**The Deficiencies in Knowledge of the Seismic Hazard for the Engineering Design of
the Proposed Chemistry and Metallurgy Research Replacement Nuclear Facility
(CMRR-NF) at the Los Alamos National Laboratory (LANL) Technical Area 55
Require Congress to Stop All Funding for the proposed CMRR-NF
- Version August 04, 2011 - By**

Fact Sheet

Figure 1. Mapped Faults in the Los Alamos National Laboratory Area.

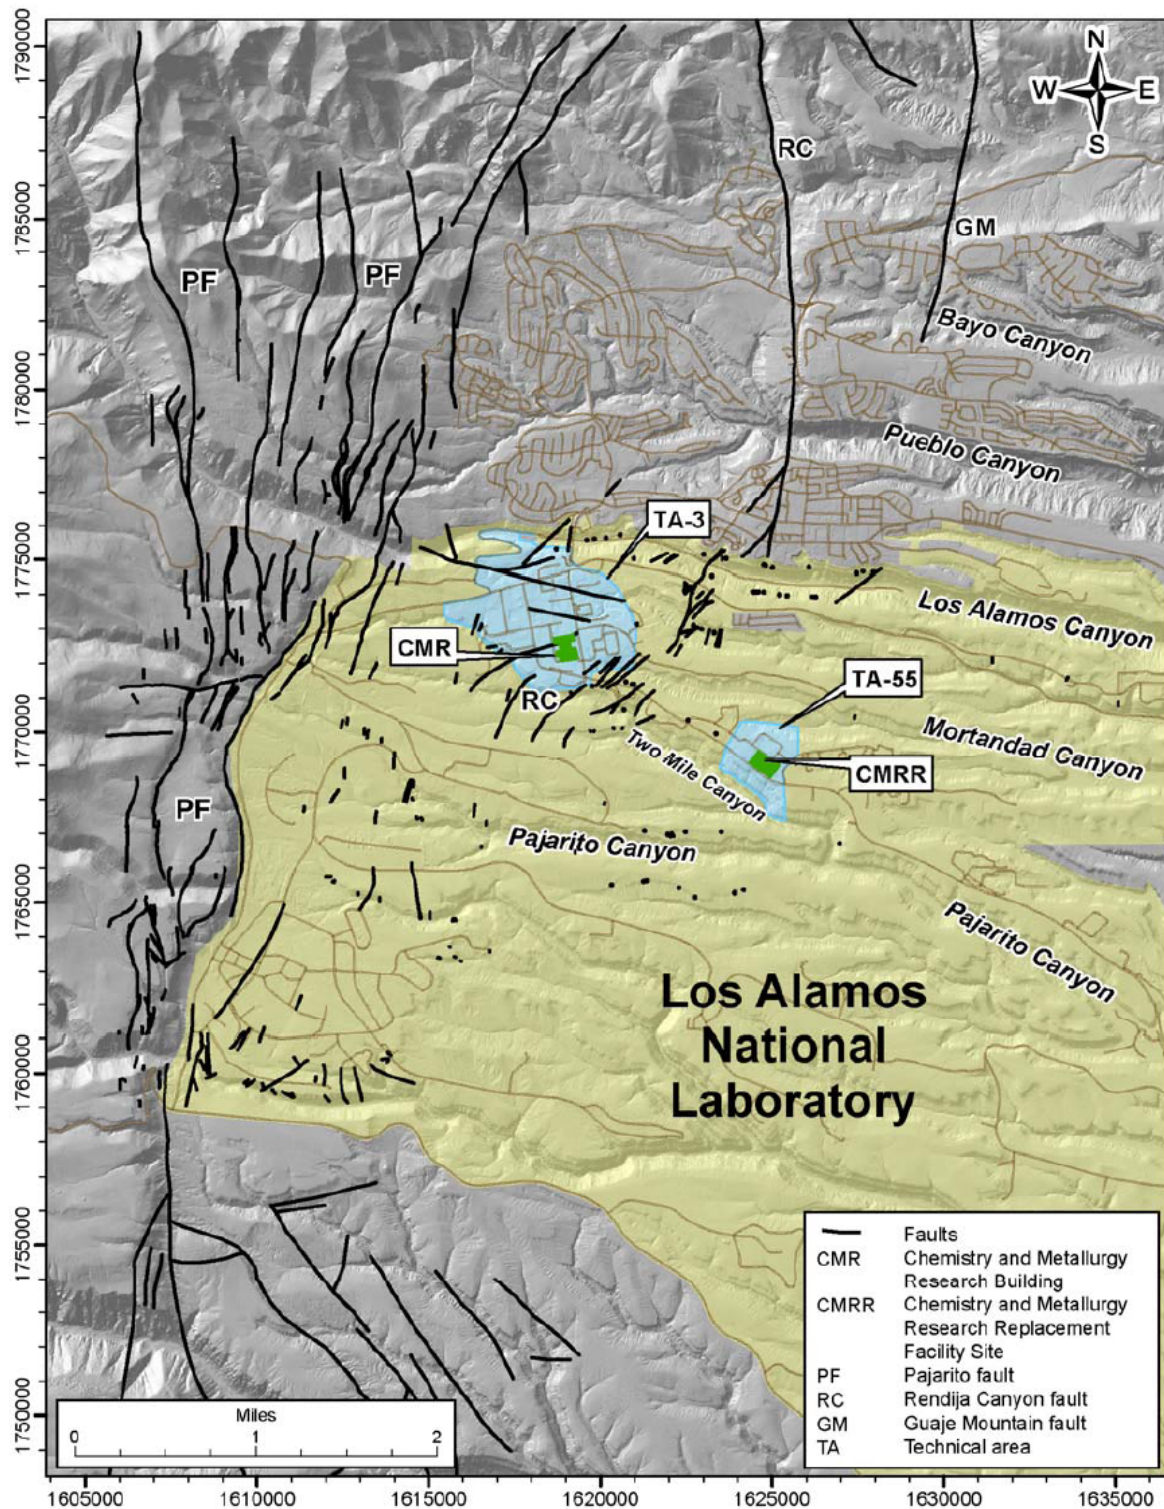
The omission of the active faults identified in Wohletz (2004) in the DOE 2011 draft SEIS (see Figure 1 and Figure 2) is a serious issue because the faults greatly increase the seismic hazard at the proposed CMRR-NF and at the existing TA-55 plutonium facility.

The 2009 paper in *Geosphere* by the LANL scientists (Lewis et al., 2009) described the need for field investigations to determine the distance of the key Guaje Mountain fault (GM on Figure 1 below from the proposed CMRR-NF SEIS):

The LANL scientists have a concern that the GMF may be located close to the proposed CMRR-NF but the seismic hazard was calculated with an assumption that the distance from the NF to the GMF was 2 ½ miles (see location of the GM fault on Figure 1). The accurate calculation of the seismic hazard at the proposed CMRR-NF requires accurate knowledge of the location and physical properties of the GMF. This knowledge does not exist and requires detailed field investigations.

Figure 2. Map in 2004 LANL Report by Wohletz showing proposed location of Rendija Canyon Fault along the western boundary of LANL TA-55 and Guaje Mountain Fault 2500 feet east of the eastern boundary of TA-55.
Source: Figure 14 in Wohletz, 2004 (LA-UR-04-8337)

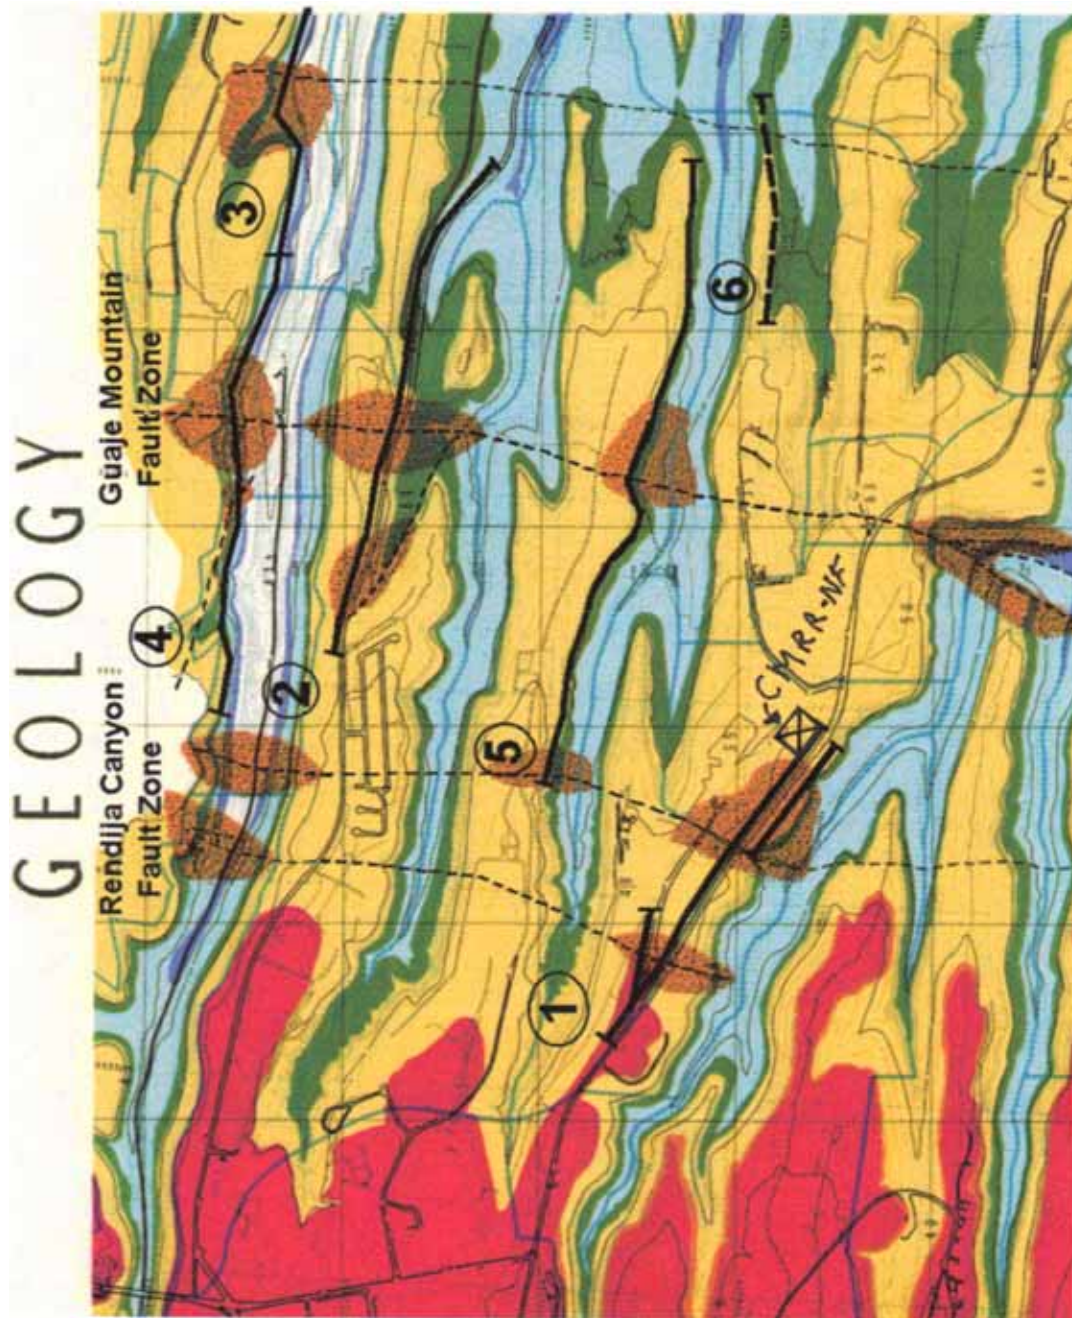
An important omission is that the calculation of the seismic hazard for the proposed CMRR-NF did not include the locations of buried active faults close to the proposed NF in the 2004 LANL report by LANL scientist Dr. Kenneth H. Wohletz. LA-UR-04-8337. The fault locations used for the seismic hazard at the proposed CMRR-NF are on Figure 1 and the active faults identified by the detailed field mapping by Dr. Wohletz are on Figure 2. The faults displayed on Figure 1 do not include the active faults identified by Wohletz (2004) at locations 800 ft west, 1600 ft north and 2500 ft east of the proposed CMRR-NF. The faults mapped in Wohletz (2004) were identified from detailed field mapping of zones of intense fractures which is a common practice in the assessment of seismic hazard.

Recent fracture mapping by LANL (Wohletz, 2004) in the north wall of Mortandad Canyon north of the CMRR site documented fracture clusters that were interpreted as southward extensions of the RCF and GMF, passing south-southwest along the west boundary of TA-55 and through TA-63 to the west and east of CMRR, respectively.
